RE: Multicultural Alliance for a Safe Environment ("MASE") comments on the Revised Updated Corrective Action Plan (2012) for the Homestake Mining Company ("HMC") in Milan, New Mexico, License No. SUA-1471, Docket No. 40-8903

COMMENTS OF THE MULTICULTURAL ALLIANCE FOR A SAFE ENVIRONMENT (MASE) TO THE STAFF OF THE UNITED STATES NUCLEAR REGULATORY COMMISSION (NRC) ON THE HOMESTAKE/BARRICK GOLD (HMC) URANIUM MILL SUPERFUND SITE UPDATED REVISED CORRECTIVE ACTION PROGRAM (CAP)

Technical Review of
Grants Reclamation Project
Updated Corrective Action Program (CAP)
NRC Radioactive Material License SUA-1471
Homestake Mining Company of California, March 2012

**Comments on the *Grants Reclamation Project, Updated Corrective Action Program (CAP)* Homestake Mining Company of California, March 2012
and Notes on RAIs**

Figure 5.3 Tailings Process Fluid Stabilization Phases

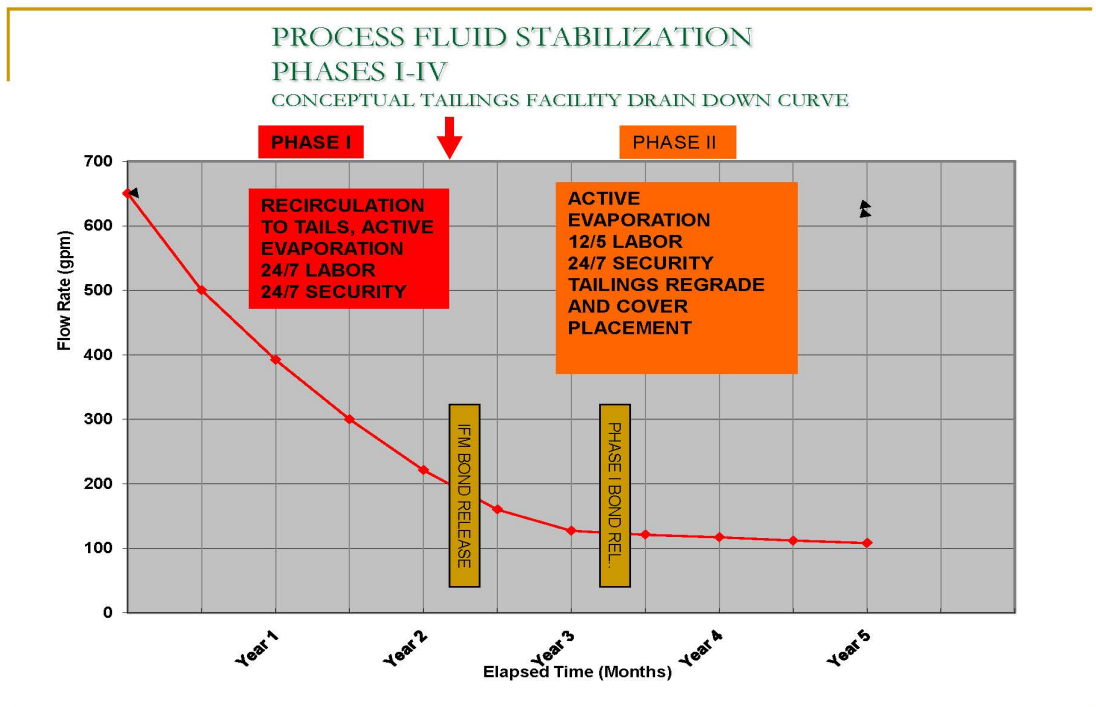
According to the CAP (p. xv) flushing of the tailings is being performed to expedite the draindown of seepage from the LTP to the groundwater. The CAP does not provide information how continuing to maintain the tailings in a saturated condition expedites draindown, when draindown is a direct function of discontinuing actions which maintain the tailings in a saturated condition thereby allowing them to drain of residual fluids. The flushing appears to prolong, rather than expedite, the draindown for as long as it is being performed.

The Nevada Department of Environmental Protection together with the Bureau of Land Management (BLM) have developed a protocol for tailings fluid management during the draindown period based on their extensive experience with tailings sites in Nevada and elsewhere. Figure 5.3² shows the various phases of draindown that are recognized. Phase 1, consisting of recirculation, is similar to the present “flushing” activity taking place at the site. As the figure demonstrates, once phase I is completed, draindown proceeds (and a final cover is placed on the tailings) which is typically followed by 30 years or more of decreasing seepage flow until steady state conditions, reflective of seepage conditions at final closure, will be realized. By continuing flushing as part of the CAP draindown and eventual final closure of the tailings is being delayed at the Grants site rather than expedited.

We recommend that immediate implementation of conventional source controls be evaluated for this site to expedite cleanup activities. This lack of typical process further demonstrates the need for an RI/FS to be conducted by EPA. This should include not only evaluation of measures to cover/cap the tailings in place, but also measures involving moving the tailings to a suitable nearby, or regional repository. Such a repository could be built using a lined system thereby preventing release of contaminants to the maximum extent.

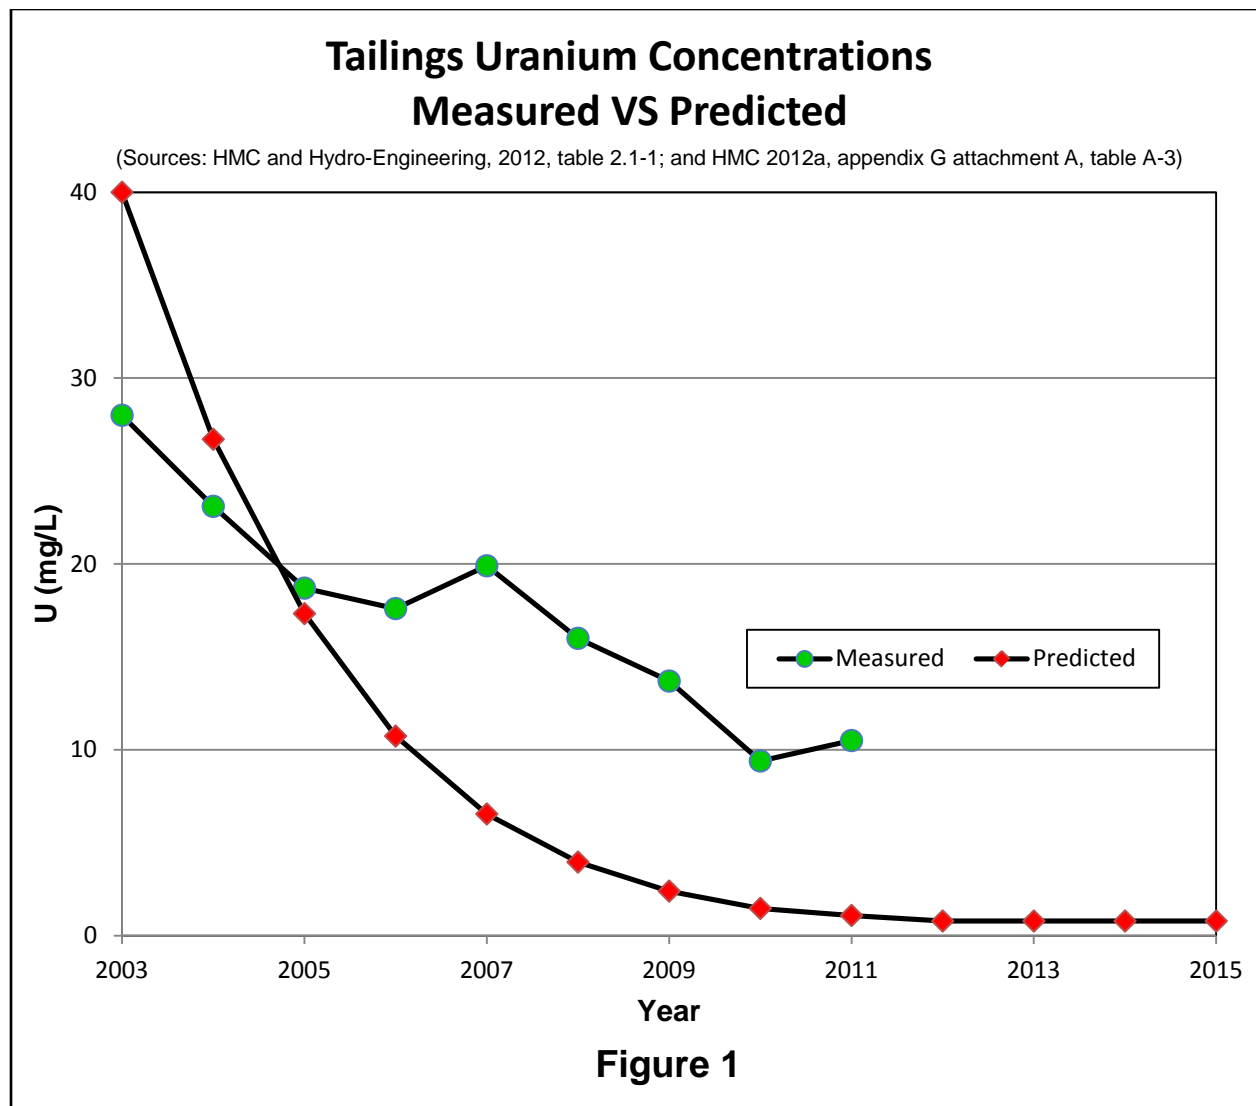
Finally, Homestake's predictions of uranium concentrations in the pile have not matched-up well with measured concentrations. This mismatch is illustrated in figure 1.

Conclusion: Although the injection of water has increased the rate at which uranium has been flushed from the pile, a significant reservoir of uranium will probably remain in the pile after injection is ceased. This uranium may continue to leach from the pile for many years or decades. Homestake should not rely on flushing to reduce this leaching to acceptable levels.
